Martin Elementary School Modernization
Project No. 01-19
Addendum No. 2
DSA Appl. # 01-116977
April 2, 2019

ADDENDUM NO. 2

DSA APPL. #01-116977
DSA FILE # 41-28
DATE: 04/02/19
REF.: 25/A2.41
SCALE: 1/8" = 1'-0"
DRAWN BY: OA
SHEET:
ASK-07

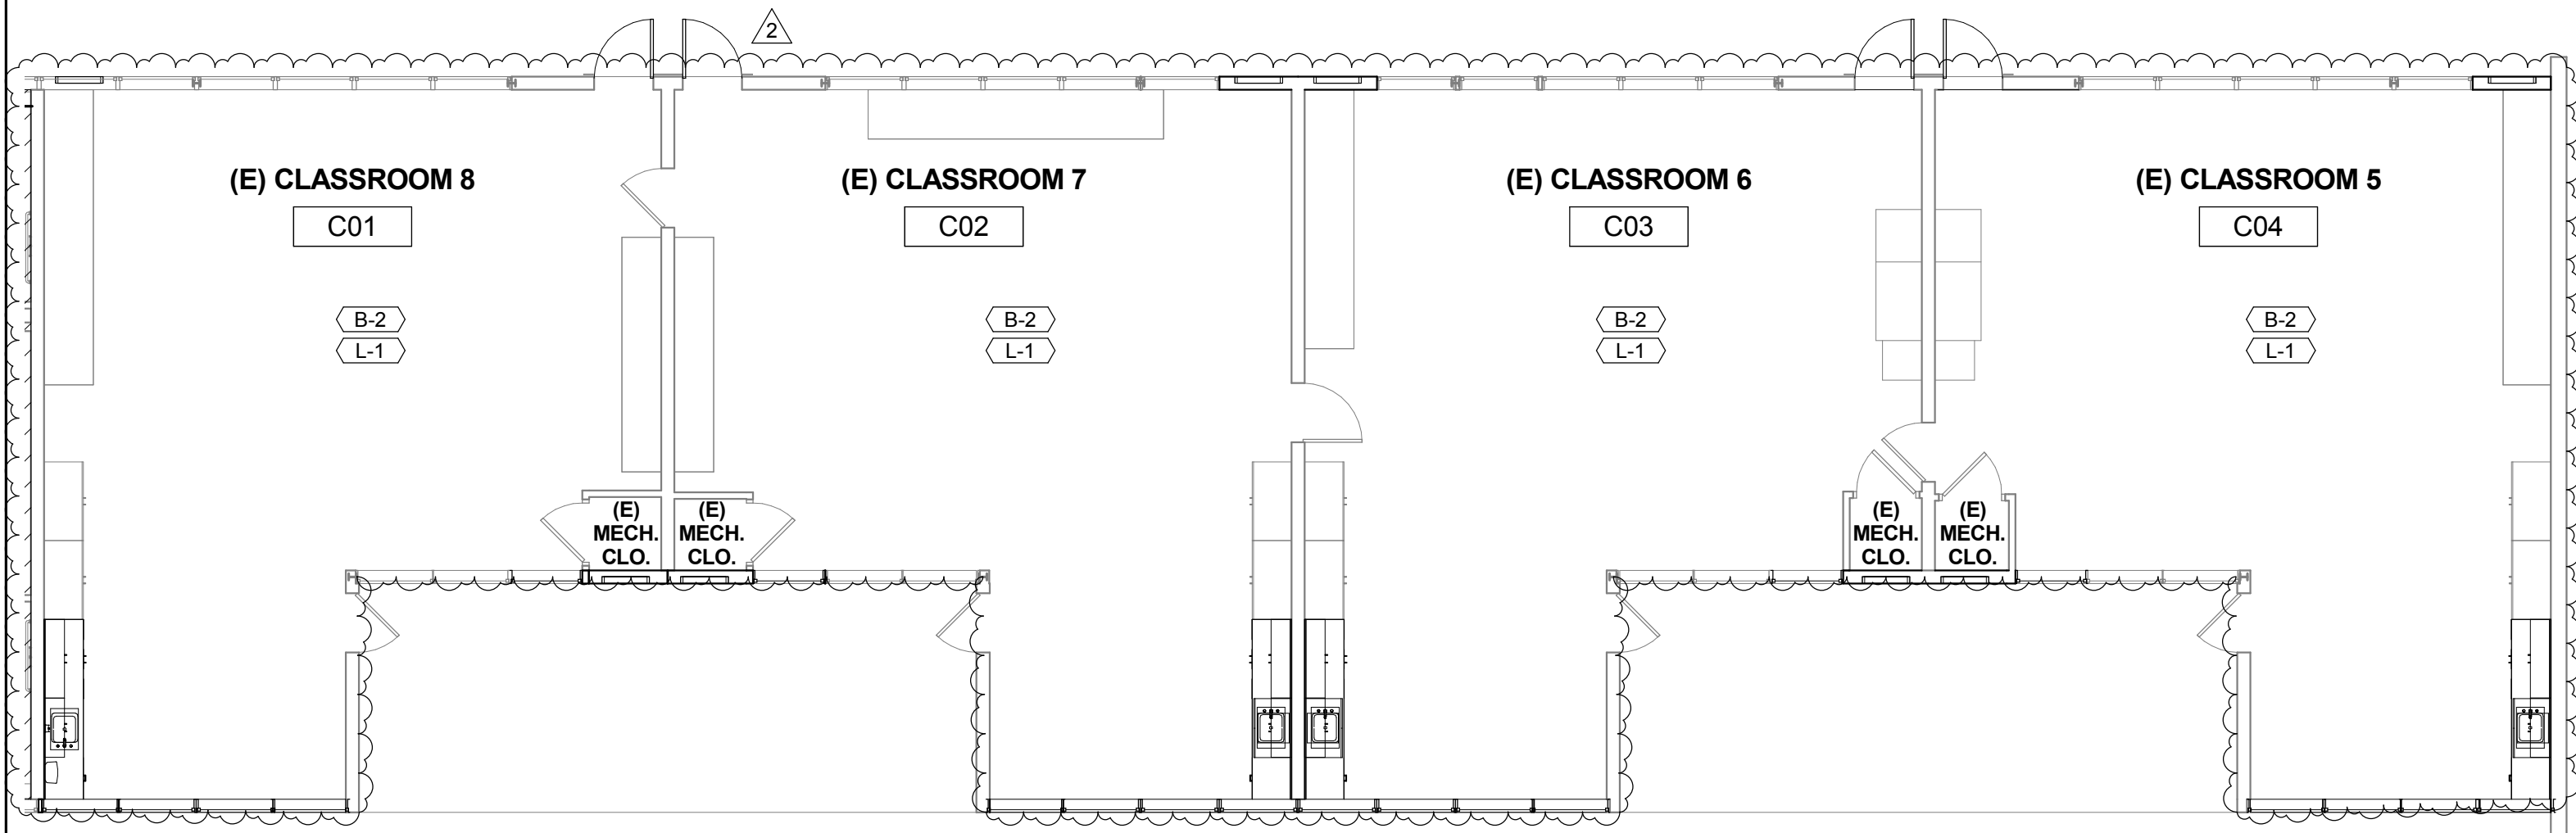
B. **Remove** VCT note. See **Attached** ASK-07

DSA APPL. #01-116977
DSA FILE # 41-28
DATE: 04/02/19
REF.: 23/A2.42
SCALE: 1/8" = 1'-0"
DRAWN BY: OA
SHEET:
ASK-08

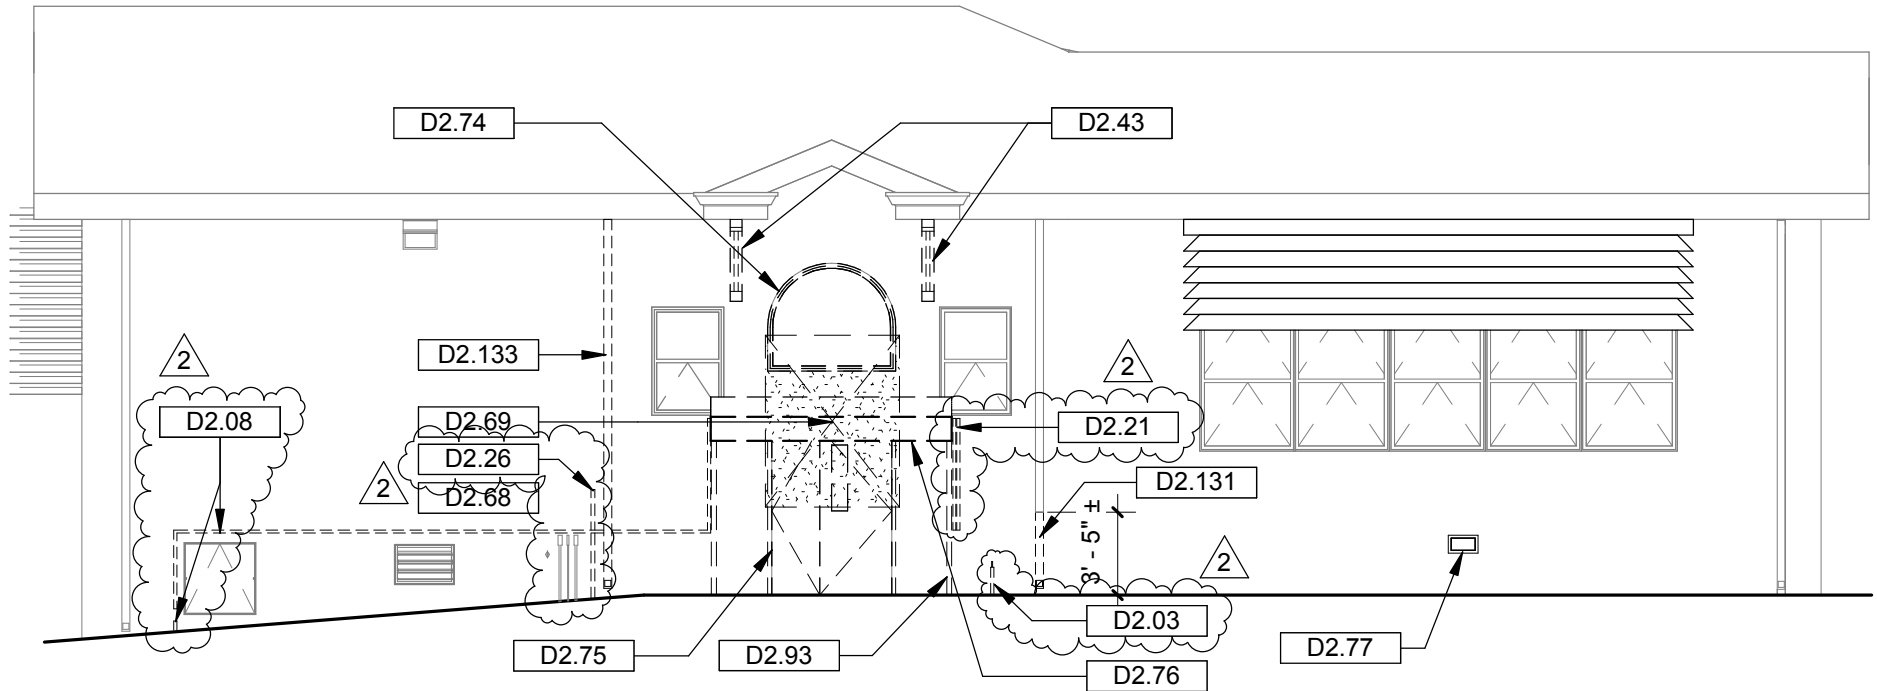
Item No. AD-2.26: Drawing Sheet A2.42 FINISH PLANS - BUILDINGS B, C, D & F – Detail 23

A. **Revise** Finishes at north door entries. See **Attached** ASK-08.

DSA APPL. #01-116977
DSA FILE # 41-28
DATE: 04/02/19
REF.: 23/A3.01
SCALE: 1/8" = 1'-0"
DRAWN BY: OA
SHEET:
ASK-09

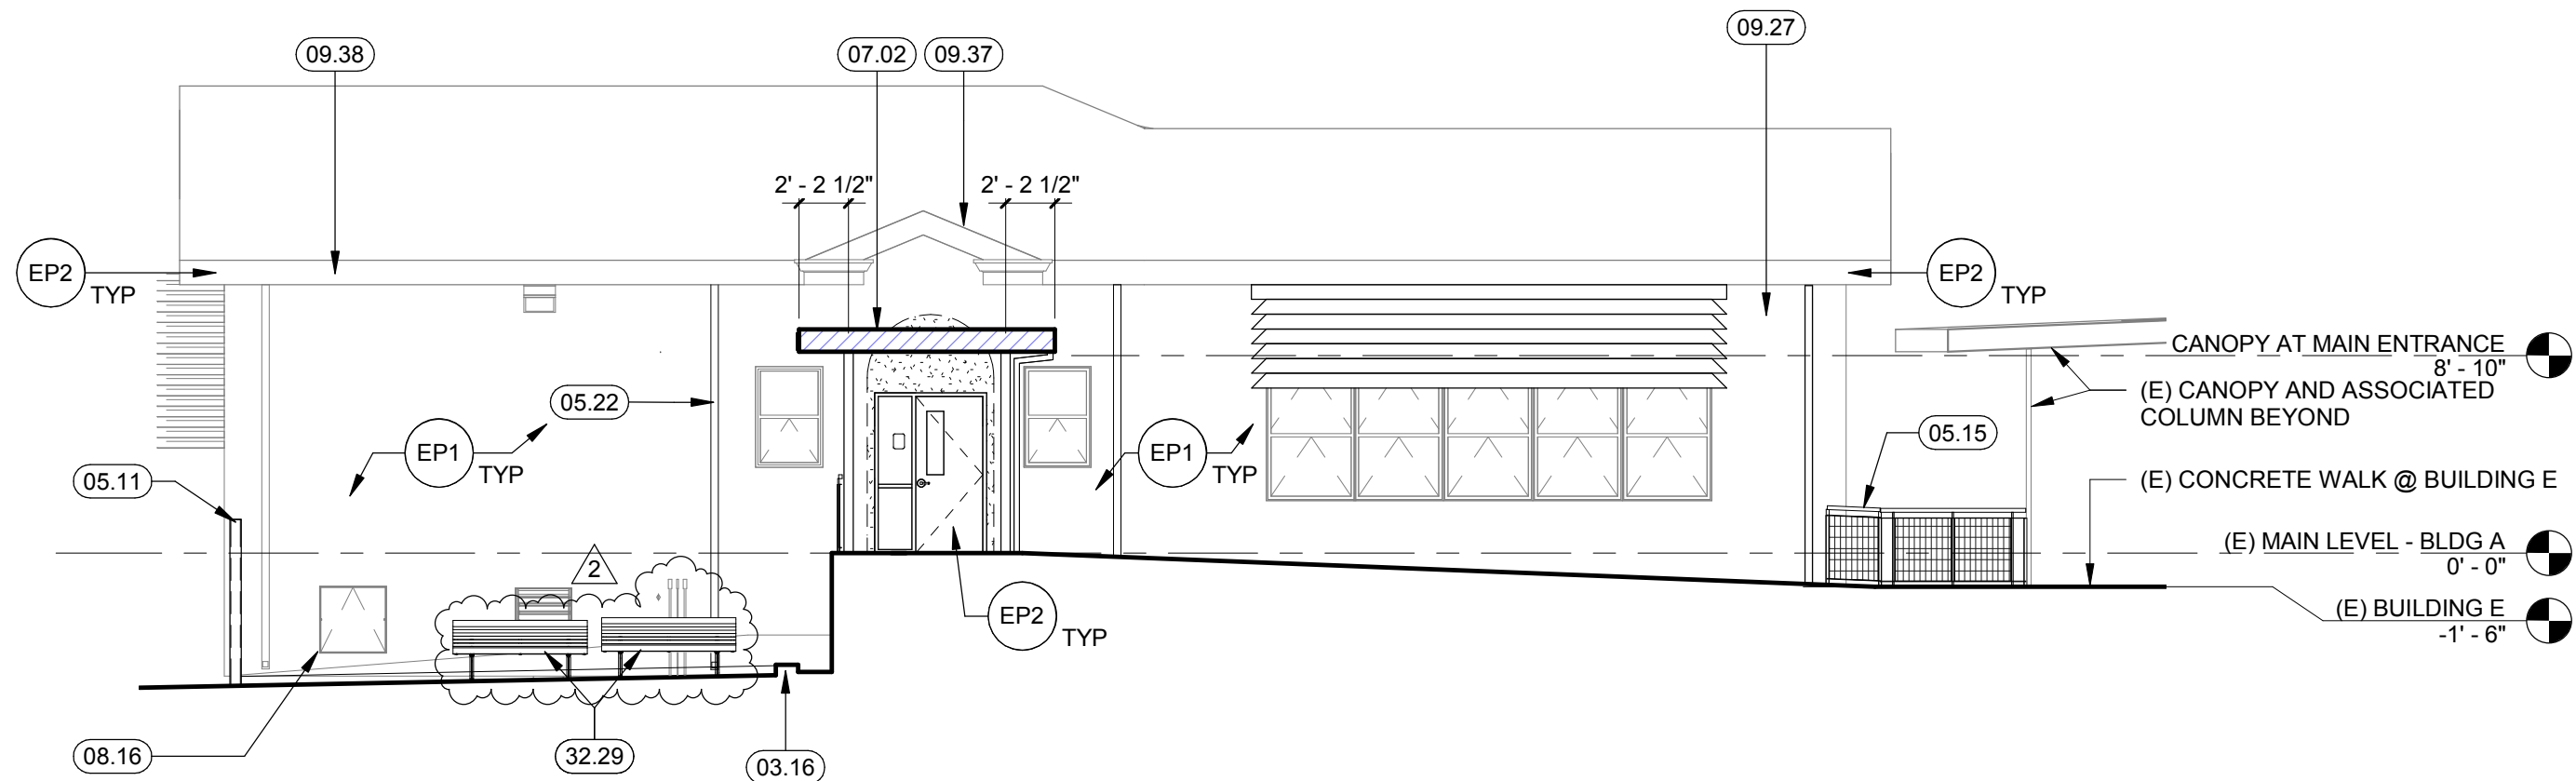
Item No. AD-2.27: Drawing Sheet A3.01 EXTERIOR ELEVATIONS DEMO - BUILDING A – Detail 23

A. **Revise** EXTERIOR ELEVATIONS DEMO - BUILDING A. See **Attached** ASK-09.

- D2.08 REMOVE (E) ABANDONED GAS PIPE. PATCH (E) CEMENT PLASTER AT WALL.
- D2.21 REMOVE (2) (E) ABANDONED INTERCOM CONDUITS BACK TO (E) MECH ROOM C07. PATCH (E) FINISHES.
- D2.26 REMOVE (E) FENCE POST AND ASSOCIATED FOOTING.
- D2.03 REMOVE (E) PIPE.

DSA APPL. #01-116977
DSA FILE # 41-28
DATE: 04/02/19
REF.: 23/A3.04
SCALE: 1/8" = 1'-0"
DRAWN BY: OA
SHEET:
ASK-10

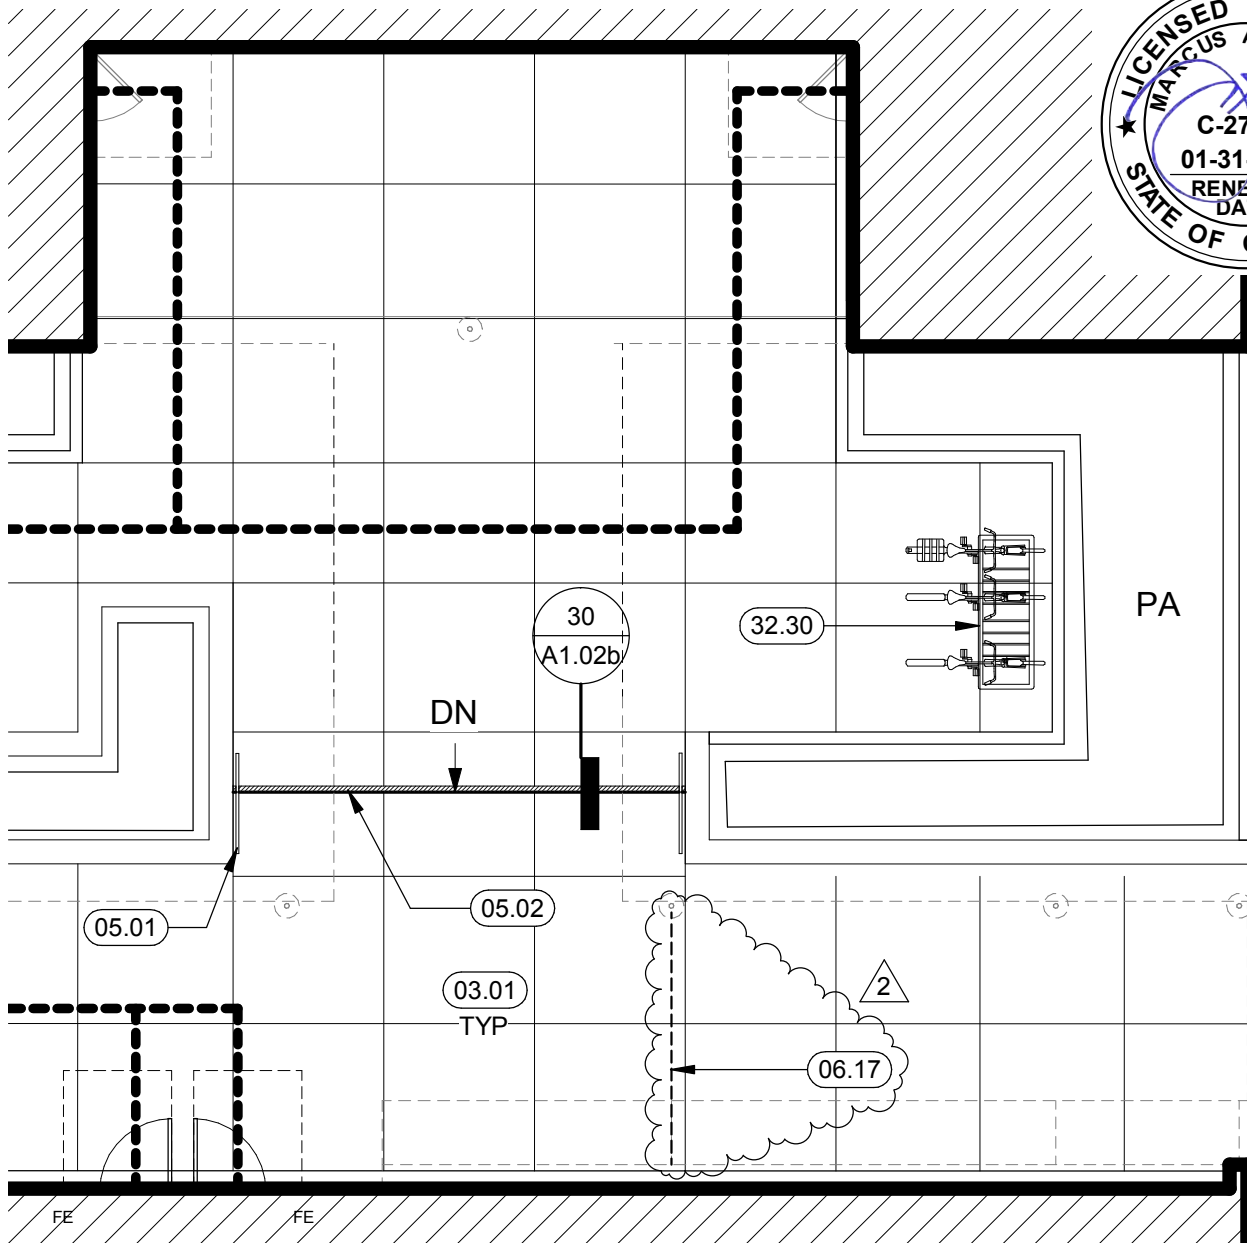
Item No. AD-2.28: Drawing Sheet A3.04 EXTERIOR ELEVATIONS NEW - BUILDING A – Detail 23

A. **Revise** graphic of benches to match specification. See **Attached** ASK-10.

DSA APPL. #01-116977
DSA FILE # 41-28
DATE: 04/02/19
REF.: C3.0
SCALE:
DRAWN BY: MS
SHEET:
CSK-03

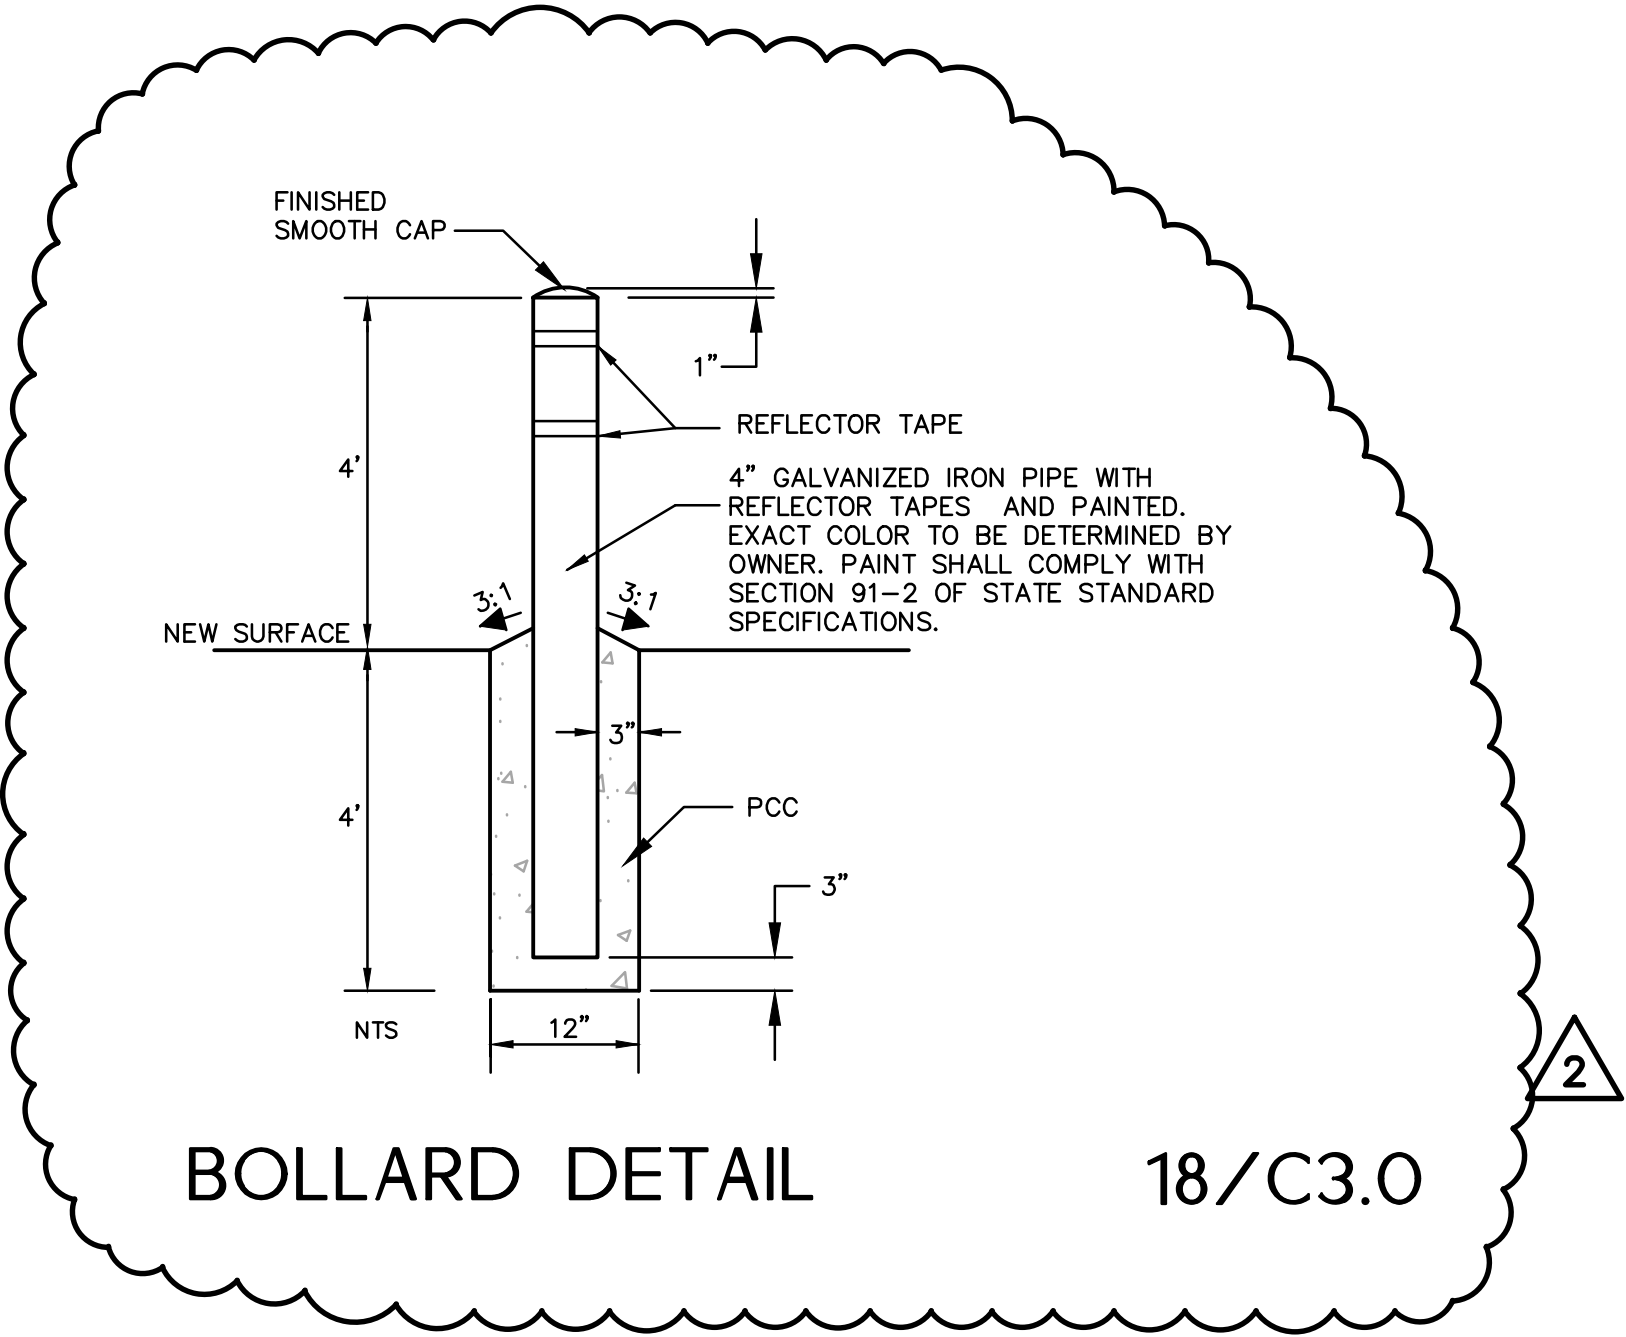
Item No. AD-2.39: Drawing Sheet C3.0 CIVIL DETAILS

A. **Add** Detail 18 BOLLARD DETAIL. See **Attached** CSK-03.
